West Elevations (amended and proposed)

West Hampstead Square

Block E Elevations

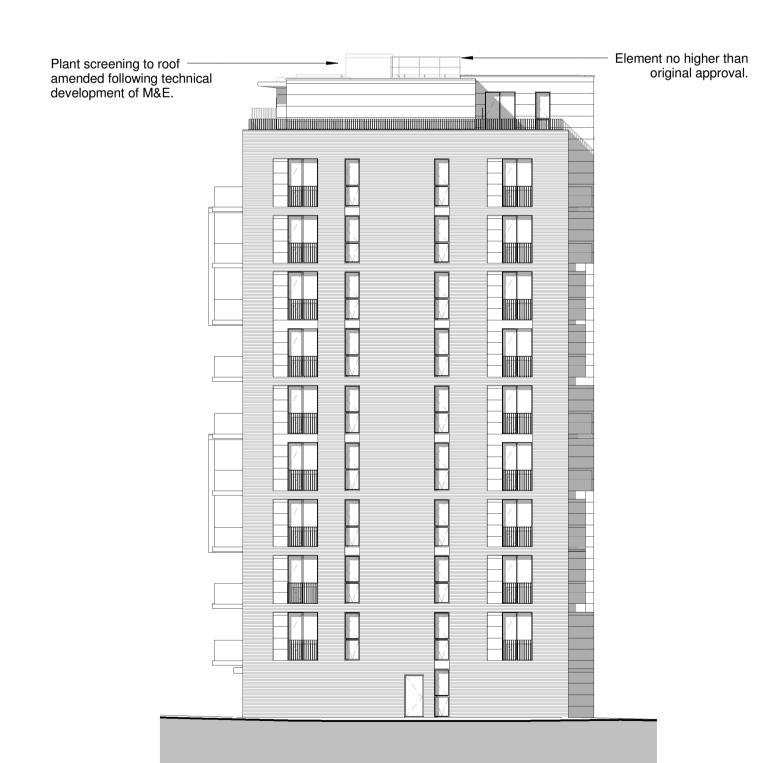
Plant screening to roof amended following technical development of M&E. Balcony added to first floor General Note Ground to first floor height reduced in technical design development to follow topography. This can be most clearly seen when comparing blocks D&E

Plant screening to roof amended following technical development of M&E.

Panel element previously terminating at second floor level now terminates at first floor
